CITY OF WOODBURN
COMMUNITY DEVELOPMENT

MEMORANDUM

Date: October 5, 2020
To: Dago Garcia, P.E., City Engineer
Cc: Chris Kerr, AICP, Community Development Director
Roy Hankins, PE, Emerio Design
From: Colin Cortes, AICP, CNU-A, Senior Planner *cc*
Subject: **Planning Division review comments on 2nd submittal / 1st re-submittal
Sept. 18 of civil engineering plans for Smith Creek Development Ph. 3B**

SMITH CREEK PHASE 3B

KILLIAN SPRING DRIVE & STORM SD-08 STA 51+50 TO 58+00 PLAN
SCALE: 1"=40'

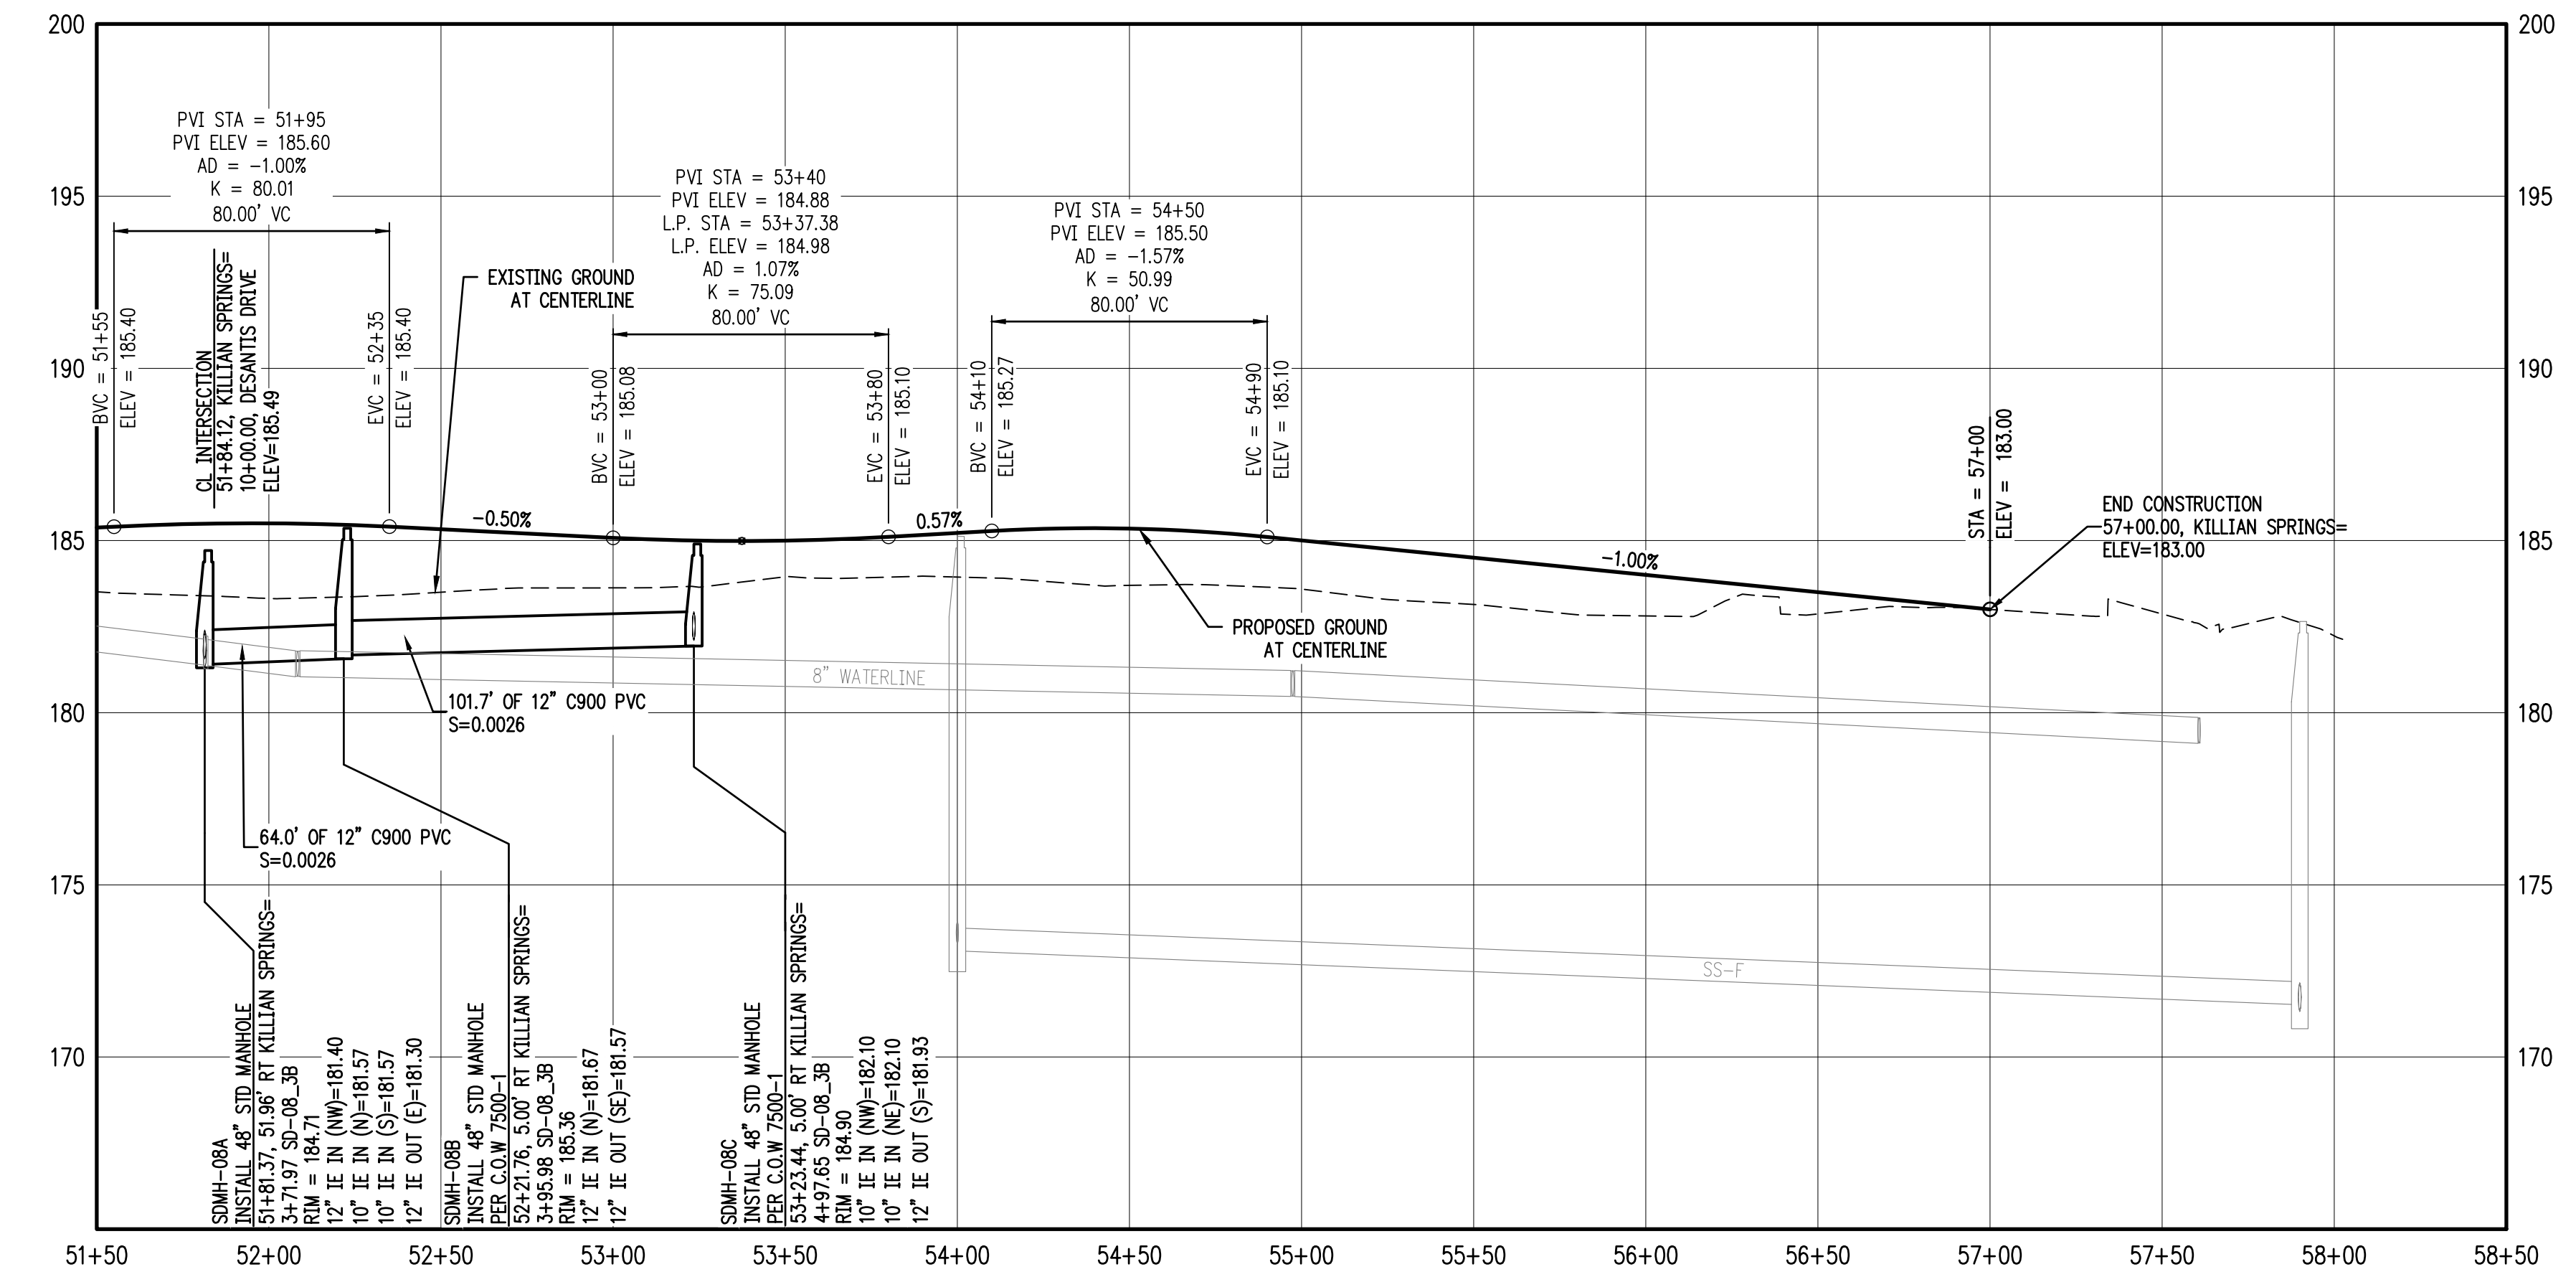
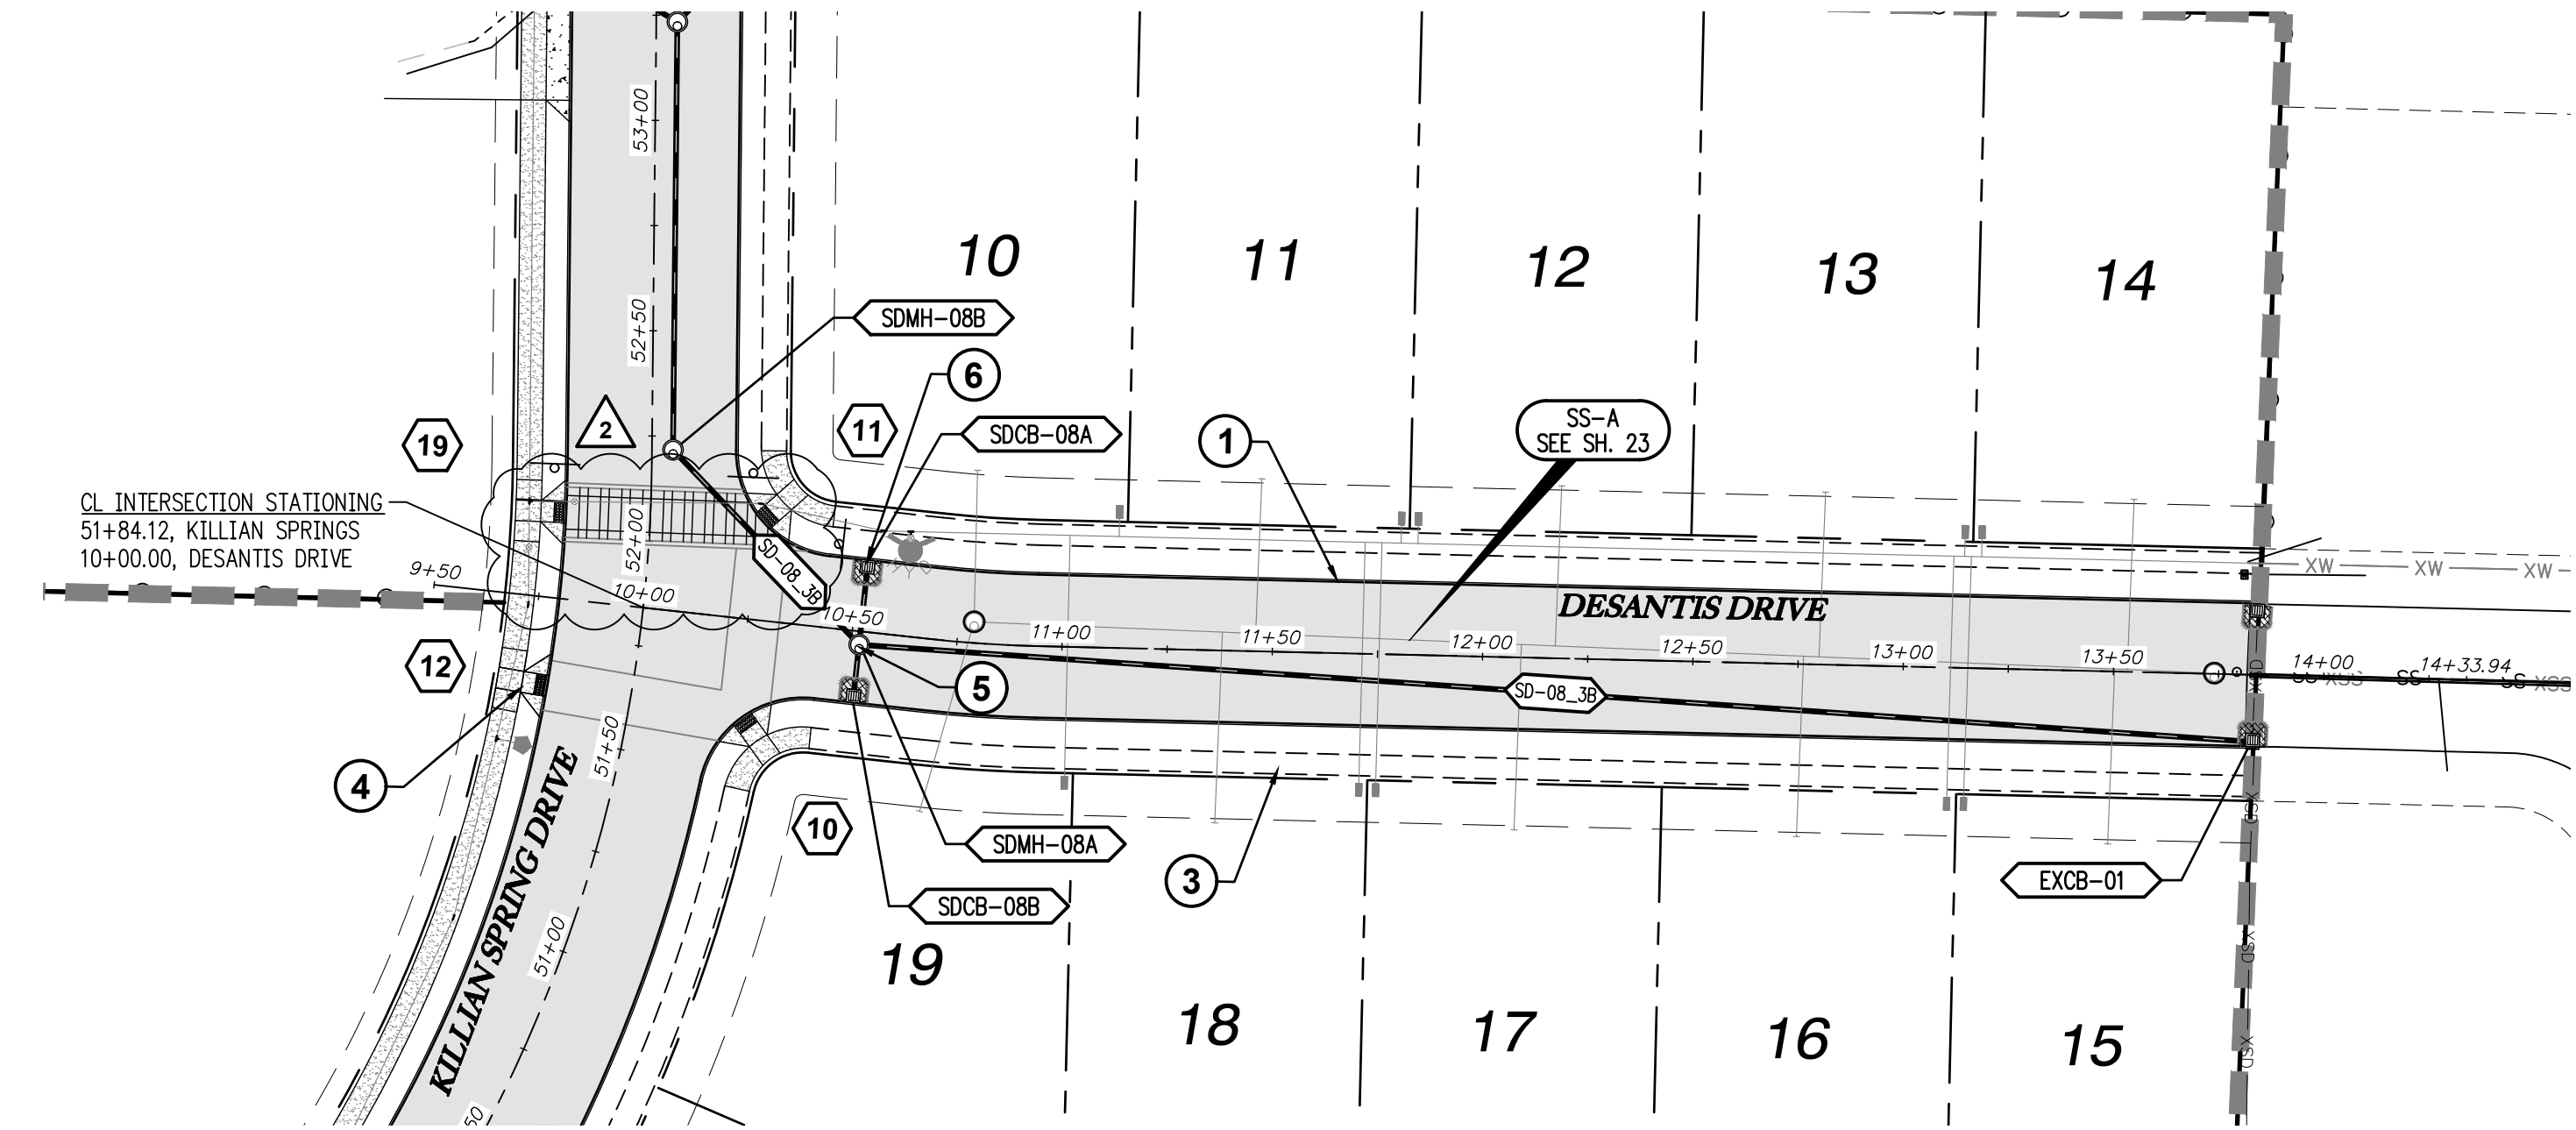
The sheets that show driveway context are missing one of two driveways along Killian Spring Drive on the Nellie Muir E.S. property. They show the north one, but not the south one.

There was an oversight. Yes, the plans are revised to show both driveways; however, the problem is that the north driveway is proposed at 32.75 ft width, the same as the drive aisle that would remain.

Revise on Sheets 10 & 26 the driveway approach / apron / curb cut and dimension label to conform; staff recommends 24 ft, the same as is the south driveway.
